State Highway 45 Post Construction Safe System Audit

Transport Choices – Barrett Road to Morley Street

Prepared for New Plymouth District Council
Prepared by Beca Limited

23 July 2025

Figure 4-1: Location on the pedestrian zebra crossing where users are concealed by the adjacent car parking

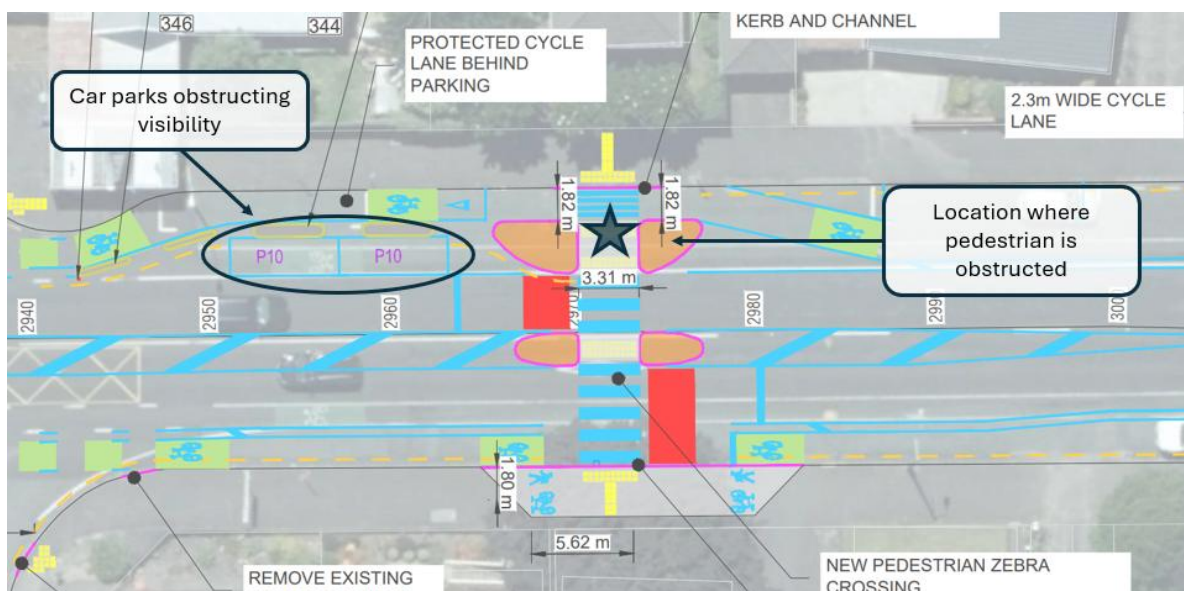
The two car parks located on the eastbound approach towards the new zebra crossing east of the SH45 / Belt Road intersection currently conceal pedestrians waiting to cross at the second stage (after crossing the cycle lane). This is particularly evident if both car parks are utilised, however, when only the westernmost (furthest back from the crossing) park is occupied, pedestrians are still concealed until the approaching vehicle is very close to the intersection. As such, the Approach Sight Distance (ASD) and Safe Stopping Distance (SSD) is reduced. This means that the approaching vehicle will likely not be able to see pedestrians crossing (or other hazards) in time to react safely and stop in time, colliding with the pedestrian. See **Figure 4-1** below.

Limited visibility for both pedestrians waiting to cross and oncoming vehicles significantly increases the likelihood of a pedestrian vs vehicle collision. This risk is further heightened by the downhill approach with restricted sightlines, where eastbound vehicles are likely to travel at higher speeds, amplifying the potential severity of a pedestrian vs vehicle collision. During the morning and afternoon peak traffic times the crossing's proximity to various school's increase the volume of vulnerable road users, such as school children. As well as being smaller, children tend to have lower cognitive, sensory, and physical abilities than adults. This means they may not approach the crossing with caution and step out onto the crossing from behind the parked vehicles without establishing visual connection with the oncoming motorist. While pedestrians do have right of way, pedestrian zebra crossings rely on visual connection between users, as opposed to traffic signals where the decision is made for you. This increases the exposure, likelihood, and severity of pedestrian and vehicle type crashes.

- It is recommended that the two carparks located to the west of the zebra crossing are removed. This will increase the sight distances for both waiting pedestrians and eastbound on-coming traffic. (Primary treatment)

Regarding Safety Concern 4.1, the Design Team partially agree with the auditors.

As noted by the SSAT, this could be resolved by removing the parking bays. An alternative option that could be considered is to recess the existing kerb and channel to the north (i.e. away from the carriageway / into the footpath). This would enable improved sight distance to be achieved, whilst also retaining the parking spaces and the safety improvements for cyclists. This option would reduce the footpath width and require design validation to ensure there are no knock-on / unintended implications (e.g. on surface drainage flows or conflicts with underground services). Another alternative option could be to swap the location of the crossing & parking bays so that the crossing is located immediately adjacent to the shops, and the parking bays further to the east. This however would require reconstruction of the crossing and potentially increase risk to pedestrians due to proximity of the crossing to Belt Road intersection (due to vehicles turning left out).

Client Decision: Agree with Designer and Safety Engineer. Kerb and channel to be recessed to achieve visibility requirements for the crossing.

Action Taken: Kerb and channel has been recessed

Figure 4-5: Standard mountable kerb detail in comparison to the concrete cycleway separators installed along the corridor

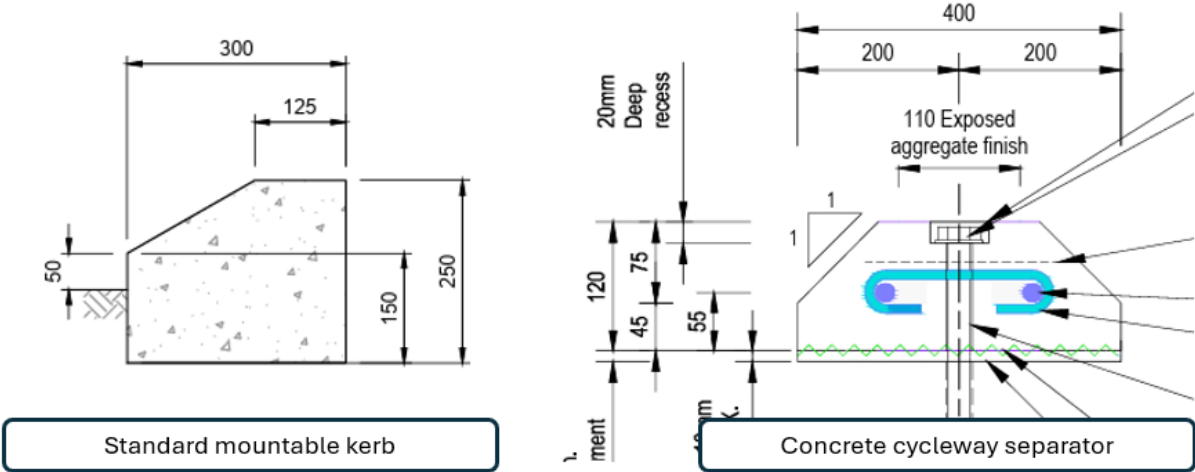
The profile for the separators suggests that they are non-mountable. While the height of the separators are in line with existing mountable kerb and channel found throughout the district, the gradient of the slope is steeper. The gradient of the slope on the separators is 1:1 as opposed to a standard mountable kerb which has a slope ratio of approximately 1:1.75. The differences between the concrete separators and a typical mountable kerb and channel is shown below in **Figure 4-5**.

- The SAT recommend that all separators are painted red on top to increase their visibility during all hours of the day, and differentiating them from the typical edge line marking.
- If space allows, offset the edge line into the lane to provide a small buffer zone between the concrete separator and the traffic lane.
- Investigate the use of alternative, more forgiving separator designs. These could be trialled in targeted areas and when replacing damaged concrete separators
- The operation of the cycleway and the crash statistics should be reviewed again within the next six months once drivers have had a chance to adjust to the new road formation.

The profile used for the concrete separators as referred to by the SSAT is a variation of the “Safety Kerb B” type profile from Figure 3.7 of the New Plymouth District Council Land Development and Subdivision Infrastructure Standard. This type of kerb profile has been used on similar projects in other parts of New Zealand and can be described as semi-mountable, since it features a chamfered edge rather than vertical face, whereas a non-mountable kerb typically features a vertical face only. The alternative kerb profile identified by the SSAT could be more accurately described as a fully mountable kerb. A fully mountable kerb profile is typically used in urban/lower speed environments, where the kerb is expected to be over-tracked on an intermittent basis (usually by larger vehicles). A key aspect of a protected cycleway design is that it provides protection to vulnerable users (i.e. the cyclist). As such, the Design Team does not advocate use of a fully mountable kerb, particularly where the separation distance between motor vehicles and cyclists is quite limited (as is the case along SH45).

In relation to the SSAT’s recommendations, we do not agree with the recommendation to paint all the separator tops with red paint. Whilst this would provide a visual contrast initially, over time, the effectiveness of the paint will diminish as it accumulates dirt and other contaminants. Additionally, painting all the separator tops red would result in significant additional cost to the road controlling authority, both up front and over the long term, since maintaining their visual effectiveness would require ongoing regular cleaning and maintenance &/or repainting regularly into the future. As such, we believe a more balanced approach is appropriate, whereby the top of the first and last separators only (in each row) are painted red to improve visibility & driver awareness. Installation of vertical delineators (i.e. mounted on top of the separators) could also be considered at select / higher risk locations.

Offsetting the separators is considered the most practical solution in reducing accidental strikes as this would provide a greater buffer for traffic.

Figure 4-9: Weaving vehicle movement (red dotted line)

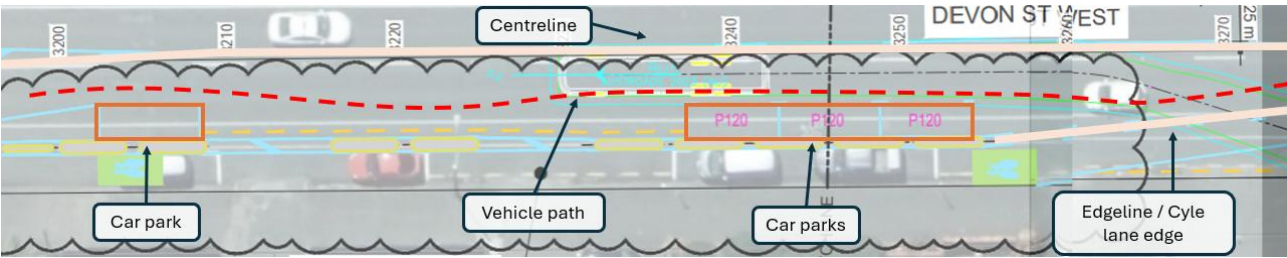
Four new car parks on SH45 / Devon Street West, located outside the 299 Motel in the mid-block section between Morley Street and Cutfield Road, extend quite abruptly toward the live traffic lane. This means that drivers need to ‘weave’ around the parked vehicles as opposed to driving in a straight line. This is exacerbated by inadequate delineation of the travel lane between the car parks and the travel lane meaning drivers are not guided to safely shift towards the centreline and away from these parking spaces. This increases the likelihood of rear end and side swipe type crashes as vehicles may swerve to avoid an unexpected, parked vehicle in their perceived travel lane. The weaving movement is shown below in **Figure 4-9**.

- Install an appropriate form of marking or guidance, such as a continuity line and/or edge definition to better position the through traffic to their lane. This will encourage better lane discipline, move the passing traffic away from the parked vehicles and offer an increased margin for door opening. This would also offer a greater margin of safety for pedestrians walking out mid-block between parked vehicles to cross the road.
- Replace the car park line marking with high performance line marking to increase their visibility, particularly in low light conditions.
- The lone parking bay near Cutfield Road intersection could be removed or joined with a continuity line with the three to the east.

Additionally, drivers are not required to weave as indicated in Figure 4-9. Rather, once they have manoeuvred to the right of the new parking bays, they can continue to travel in a straight line, following the centreline of the road as is normal practise.

Nonetheless, the Design Team agree that improved delineation could be provided by way of marking a white edgeline, which tapers gradually from the buffer marking adjacent to the bus stop, and continues west adjacent to the parking bays, matching into the end of the newly marked edgeline beyond the final bay. The edgeline would ideally be offset by a minimum of 600mm from the edge of the bays, and would help guide drivers away from the new parking bays and provide separation between parked and through vehicles on SH45. The Design Team understand that changes which are proposed to the existing centreline (i.e. to shift it to the north) have yet to be implemented. To accommodate a 600mm buffer within the existing width available, we estimate that the lanes on SH45 would need to be marked at 3m wide over this short section. Also, the three P120 bays may need to be moved slightly west.

Figure 4-12: Unclear vehicle positioning and lane delineation for right turning vehicles at the SH45 Devon Street West / Morley Street intersection

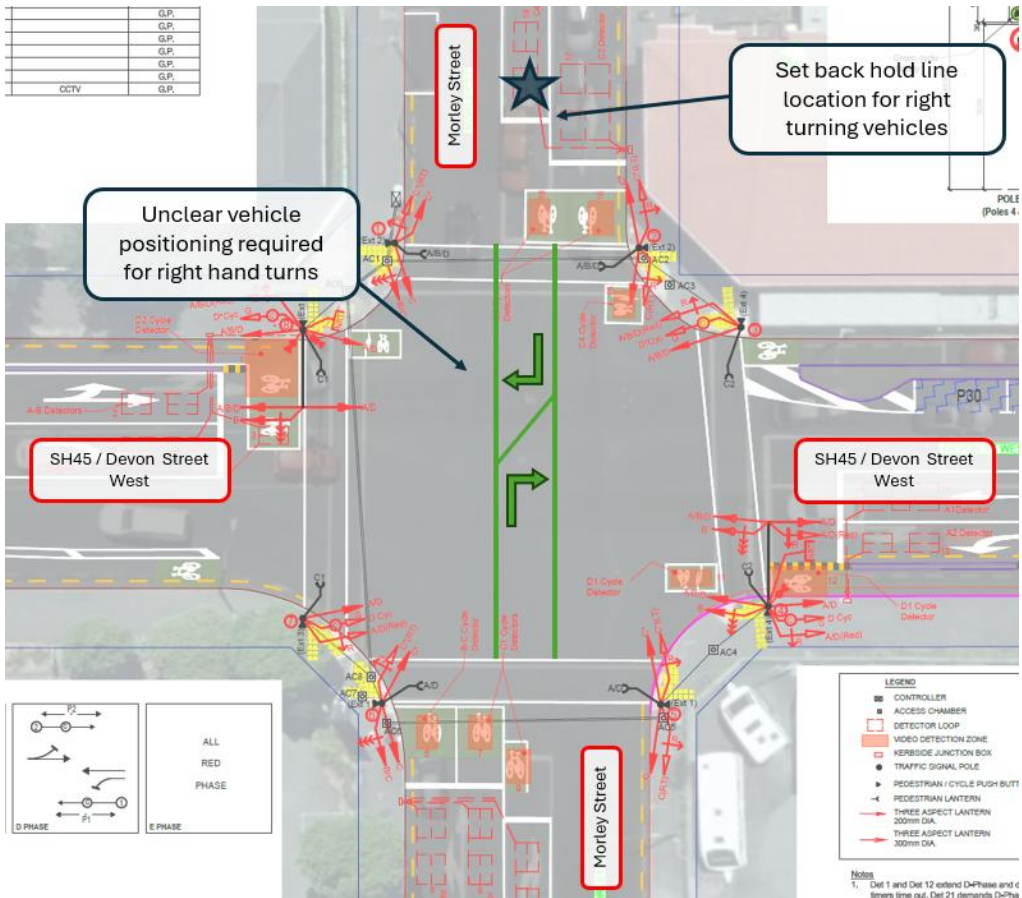
The vehicle positioning required for these right hand turns is also unclear. Drivers turning right may not be guided properly at the intersection and encroach into the opposing vehicle lane when making these right turn movements. The lack of position guidance within the intersection before turning further increases the likelihood of intersection type crashes for right turning vehicles. This is shown in **Figure 4-12** below.

- Provide right turn green signal arrows from Morley Street onto SH45 / Devon Street West.
- If filtered turning is deemed to be necessary, consider providing right turn pockets within the intersection in line with the NZ Transport Agency Waka Kotahi Traffic Control Devices manual

Design Team Response: SIDRA modelling was undertaken for this intersection as operational changes were to be implemented that affected the capacity of the intersection. At that time, it was determined that for ongoing smooth operation of this state highway intersection, filter turning for the Morley Street approaches would be necessary. This was not seen as a safety risk, as filtering through a single lane of oncoming traffic is regarded as safe, if there are adequate gaps in the traffic flow (which is the case here). However, the design team agrees that vertical alignment provides visibility restrictions, and that these visibility restrictions should be addressed through encouraging drivers to pull into the intersection through guide markings as shown in Figure 4-12. The design team agrees that these guide markings should be retrofitted. This will be considered alongside the next item 4.7.

The provision of right turn green signal arrows would provide for a safer outcome as it separates conflicting movements, however this change would reduce the efficiency of the intersection (I.e greater delays to every other movement), which a balance between safety and efficiency should be considered.

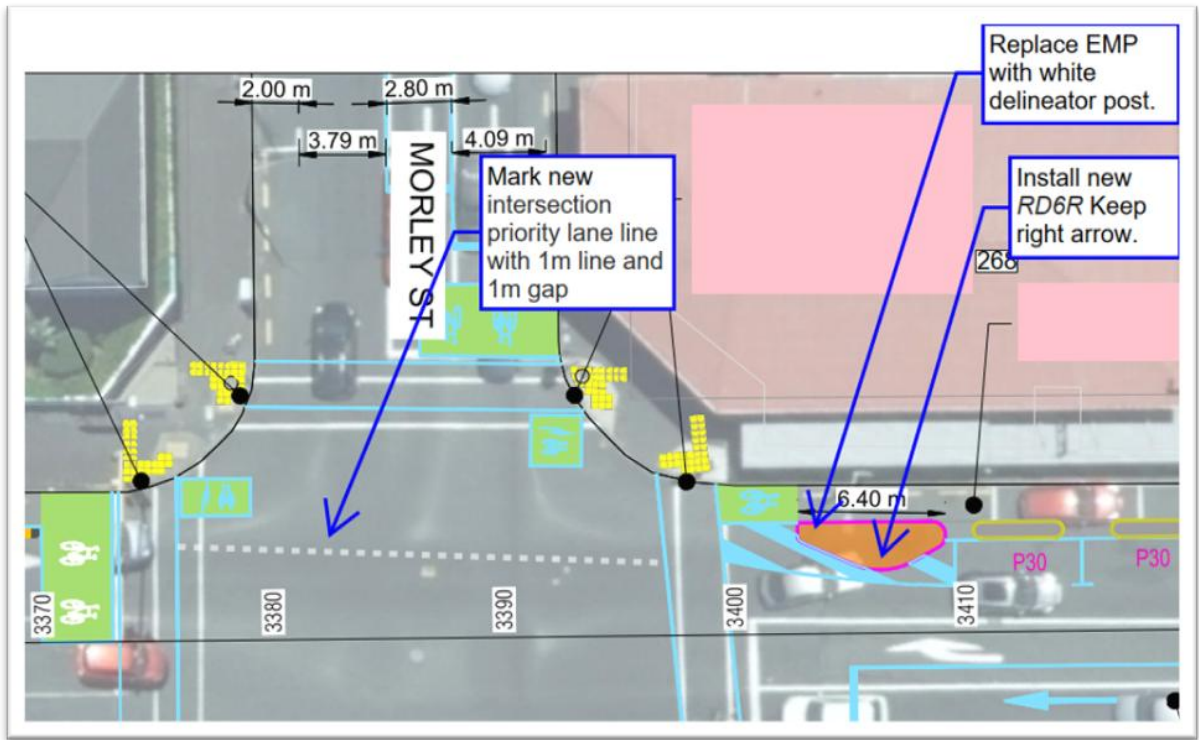
Drivers face the risk of colliding with or driving over the island, which could lead to a run-off-road crash. However, the likelihood of severe crashes at this location is relatively low, as it is expected that vehicles are typically travelling at lower speeds through intersection. The islands concealment is shown below in **Figure 4-13**.

- The SAT recommend that a reflective directional sign is installed on top to help better guide eastbound drivers to deviate slightly to the right when travelling through the intersection such as ‘keep right arrow’.

The Design Team agree with auditors.

White edge marker posts (EMPs) are not an appropriate form of delineation in the urban area or for this type of application. We agree that an RD6R Keep Right Arrow sign should be used to replace the EMP in the right of the photo. We also recommend that the edge marker post on the left of the photo is replaced with a white delineator post. An intersection priority lane line could also be marked to delineate the edge of the traffic lane through the intersection as shown in the image below.

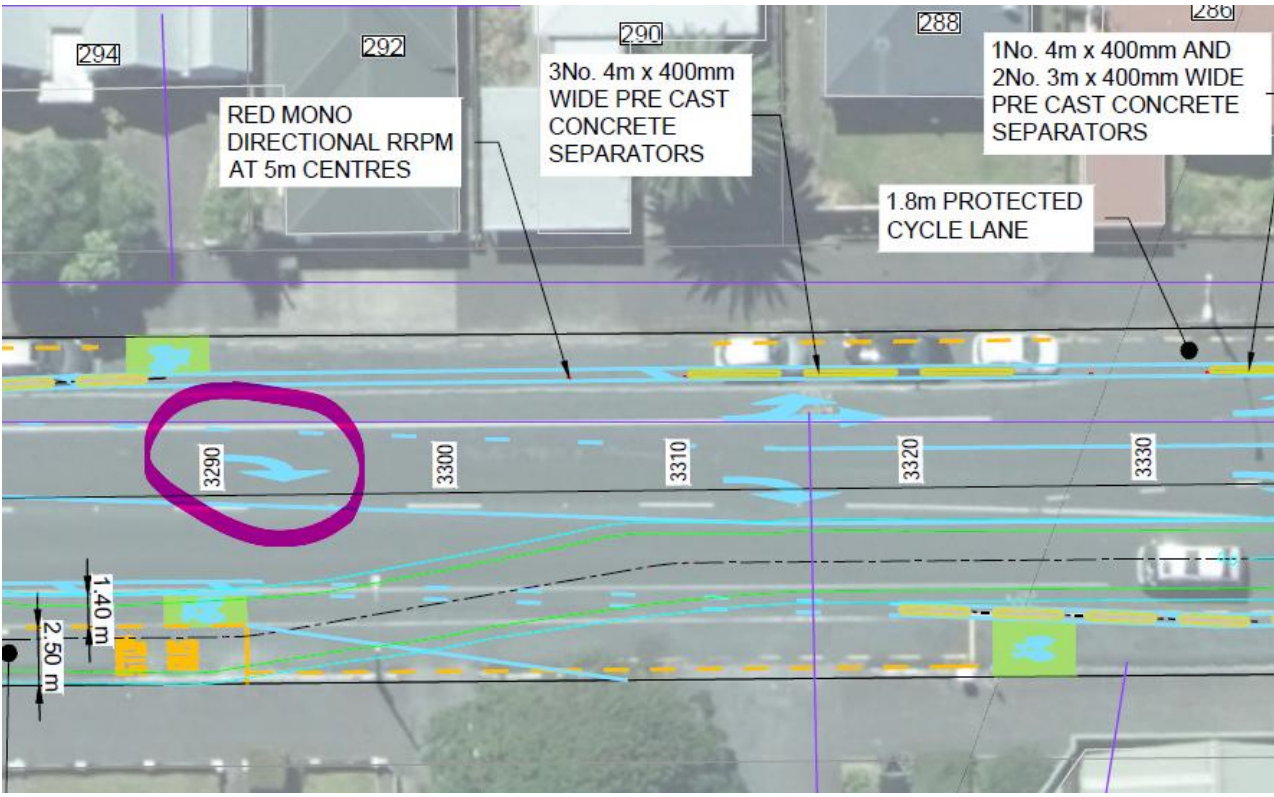
The trap lane configuration is shown below in **Figure 4-14**.

Design Team Response: The design of a captured lane was deliberate and guided by the wishes of the two road controlling authorities involved. The intention was that by default, drivers would follow the alignment of the state highway, rather than being channelled into the central city. That said, it has been noticed that the design has not been fully implemented, as the first right turn arrow that approaching drivers would face is missing. This should be retrofitted, as it avoids trapping drivers inadvertently in the exclusive right turn lane. The missing lane arrow is highlighted on the figure below.

Agree with Design Team response. SH45 is the main traffic route, carrying the higher traffic volume. The layout provides for greater queuing and throughput for the right turn movement.
